# California Department of Transportation

SCH #: 2022080104 GTS #: 04-SOL-2022-00253 GTS ID: 27304 Co/Rt/Pm: SOL/12/2.402

# Re: 80-12 Industrial Center – Initial Study/Mitigated Negative Declaration (IS/MND)

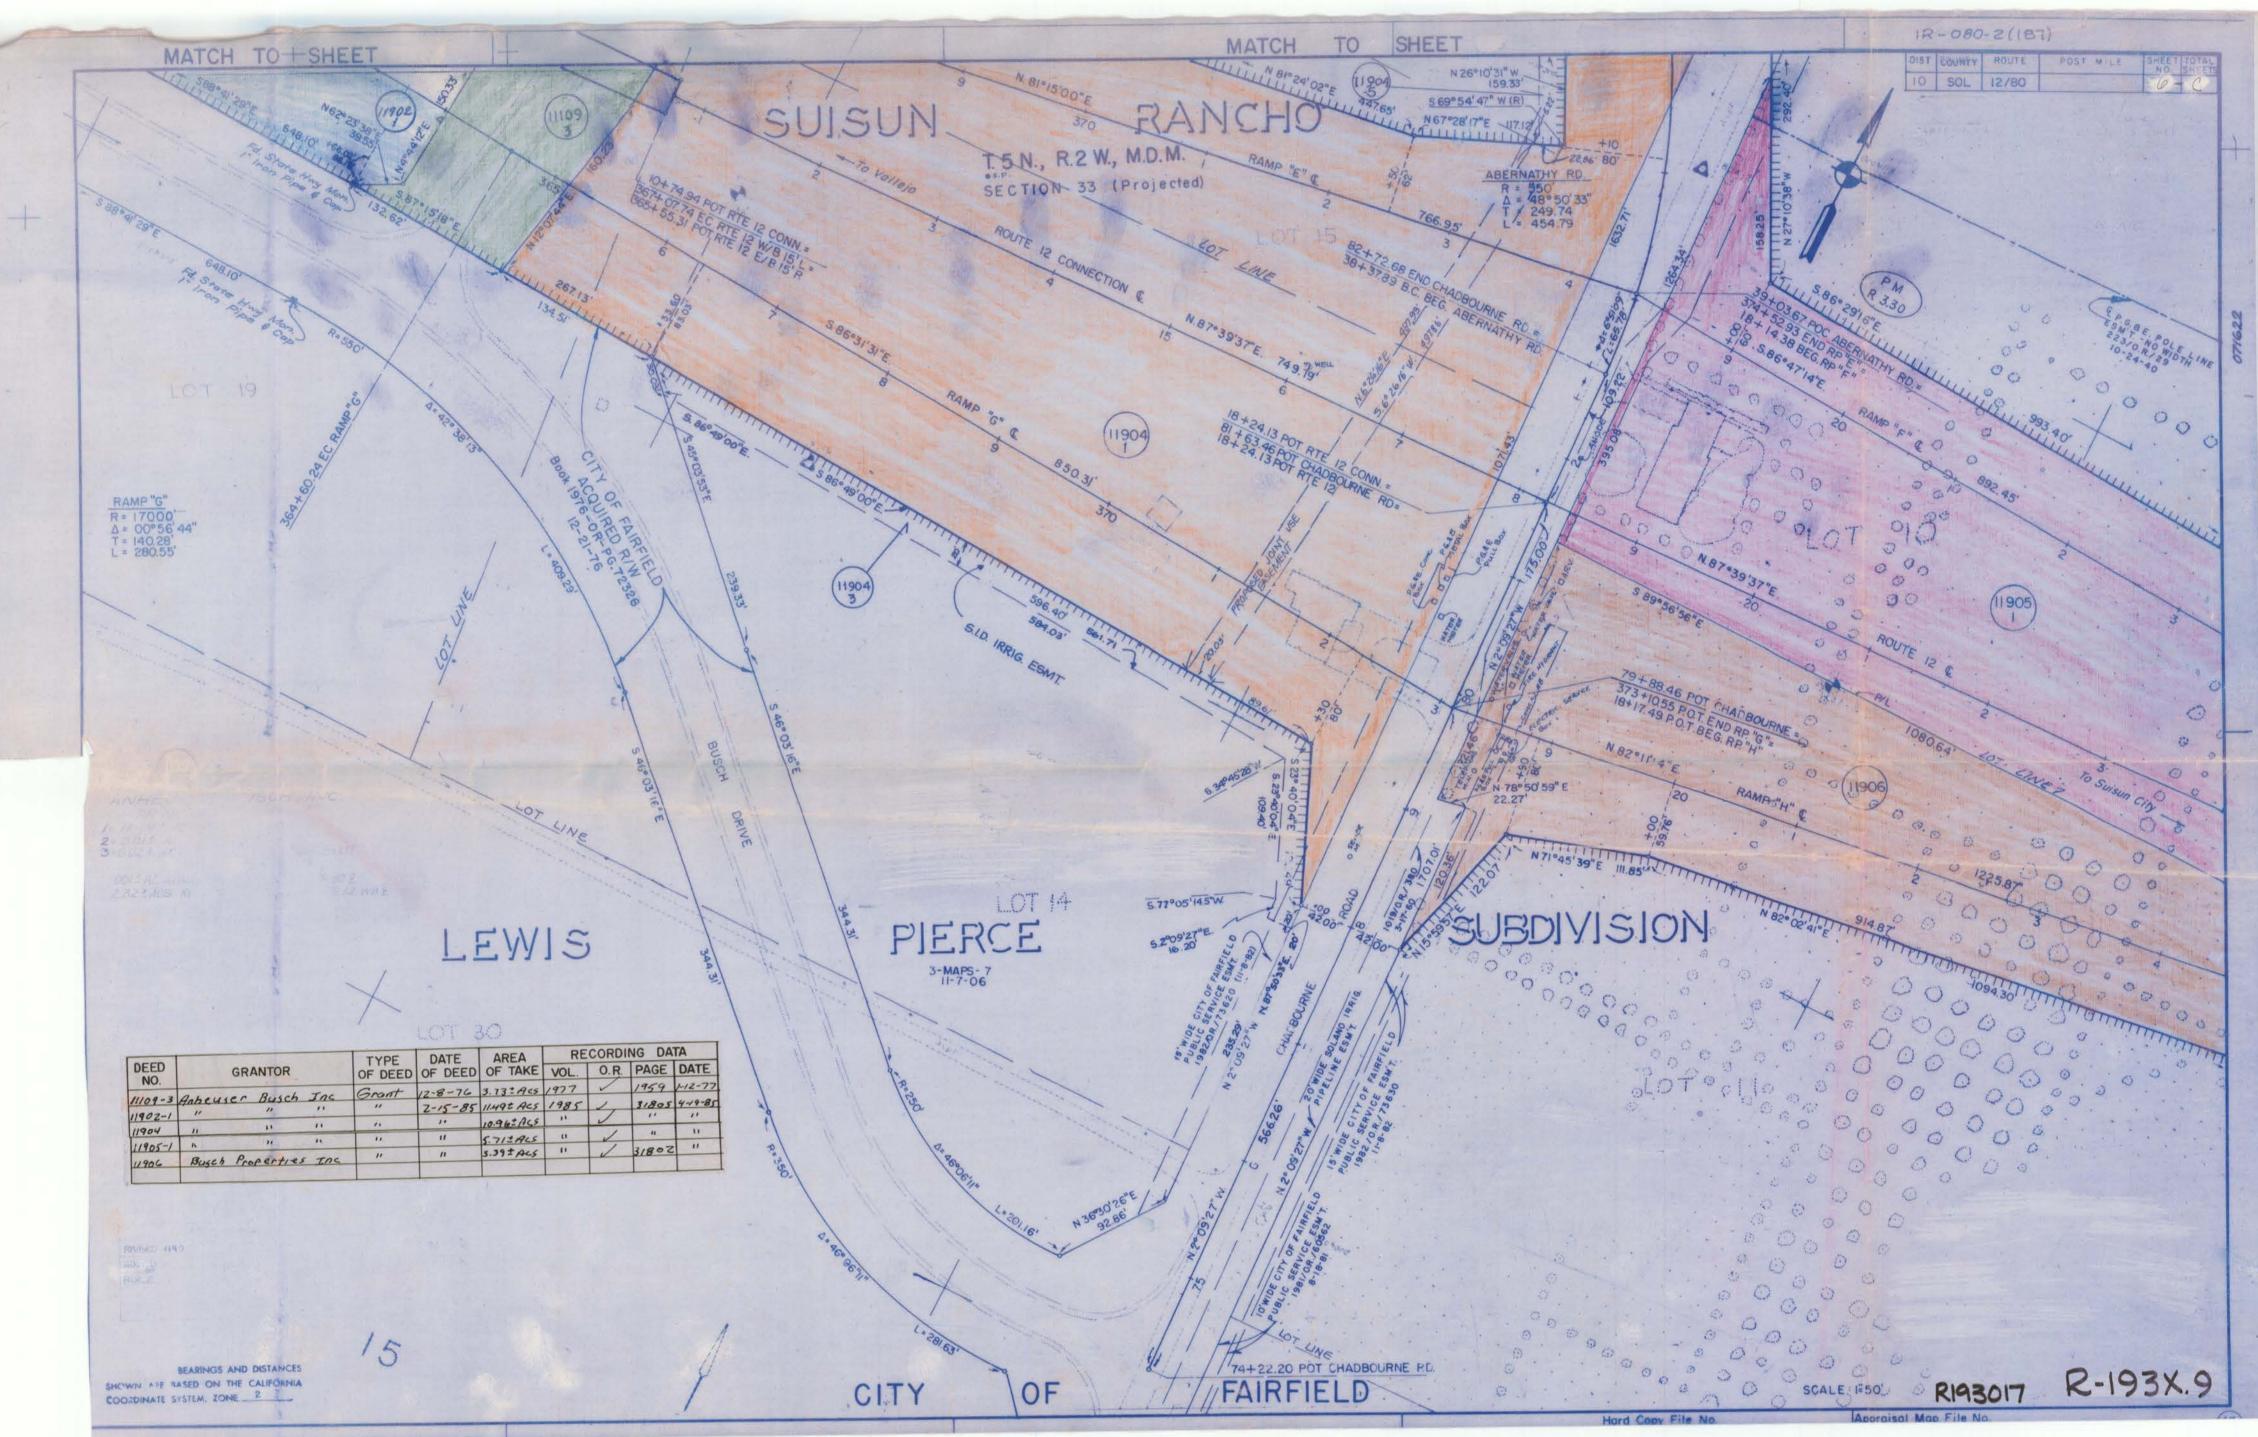
Please ensure that the northerly driveway would not infringe on the access control area (see enclosed map). Any permanent work or temporary traffic control that encroaches onto Caltrans' Right-of-Way (ROW) requires a Caltrans-issued encroachment permit. As part of the encroachment permit submittal process, you may be asked by the Office of Encroachment Permits to submit a completed encroachment permit application package, digital set of plans clearly delineating Caltrans' ROW, digital copy of signed, dated and stamped (include stamp expiration date) traffic control plans, this comment letter, your response to the comment letter, and where applicable, the following items: new or amended Maintenance Agreement (MA), approved Design Standard Decision Document (DSDD), approved encroachment exception request, and/or airspace lease agreement. Your application package may be emailed to D4Permits@dot.ca.gov.
